# Access Compliance Report

## Public Rights-of-Way

### (Curb Ramps)

Intersection ID: 52716	Main Street: AGAVA_LN	Cross Street: MAIDENHAIR_CT	Location: NE
ADA ID: A26E7266FF7D	Ramp Type: Perp	Initial Pass/Fail: Pass	Overall Compliance: No
Codes/Mitigation Info/Possible Solution			Severity Score: 2.5
			Field Measurements/Component Compliance

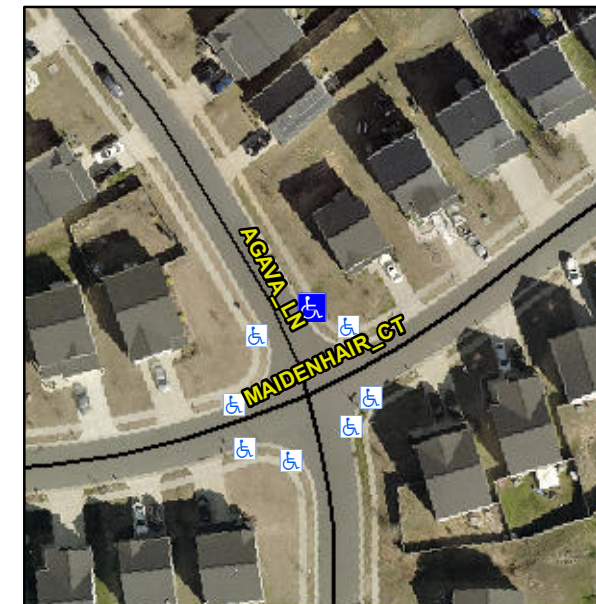
**Not Found, R304.2.1, R304.5.3,  
R305.1.4, R305.2**

Compliance	Description	Data	Compliance	Description	Data
N/A	Ramp Length (in)	47.0	Yes	Ramp Slope (%)	6.5
Yes	Ramp Width (in)	48.0	Yes	Ramp XSlope (%)	1.2
N/A	Flare Type LT	Sloped	N/A	Flare Type RT	N/A
N/A	Flare Slope LT (%)	2.4	N/A	Flare Slope RT (%)	5.0
N/A	Flare Traversable LT?	No	N/A	Flare Traversable RT?	No
No	Landing Length (in)	46.0	Yes	DWS Provided?	Yes
Yes	Landing Width (in)	48.0	Yes	DWS Contrast?	Yes
Yes	Landing Slope (%)	0.5	Yes	DWS Length (in)	24.0
No	Landing X Slope (%)	2.4	No	DWS Full Width?	No
N/A	Landing Curb? (Y/N)	No	No	DWS Offset (in)	3.0
N/A	Shared Landing?	No			
Yes	Gutter Ponding?	No	Yes	Gutter Slope (%)	2.0
Yes	Gutter Lip Ht (in)	0.0	No	Gutter X Slope (%)	2.3
N/A	Painted X Walk1?	No	N/A	Painted X Walk2?	N/A
	X Walk 1 Direction	To W		X Walk 2 Direction	N/A
N/A	X Walk 1 Width (in)	N/A	N/A	X Walk 2 Width (in)	N/A
	X Walk 1 Slope (%)	1.6		X Walk 2 Slope (%)	N/A
	X Walk 1 X Slope (%)	2.2		X Walk 2 X Slope (%)	N/A

N/A	Ramp inside XWalk1?	N/A	N/A	Ramp inside XWalk2?	N/A
	Road Slope (%)	N/A	N/A	Clear Space?	Yes
	Road X Slope (%)	N/A	N/A	Clear Space to XWalk (in)	N/A
Yes	Any Obstructions?	No	Yes	Storm Grate/Utility Hazard?	No
	Obstruction Type			Storm Grate/Utility Type	
		N/A			N/A
			Yes	Surface Condition? (G/P)	Good

**Remove & Replace Entire Ramp.  
Remove & Replace Gutter.**
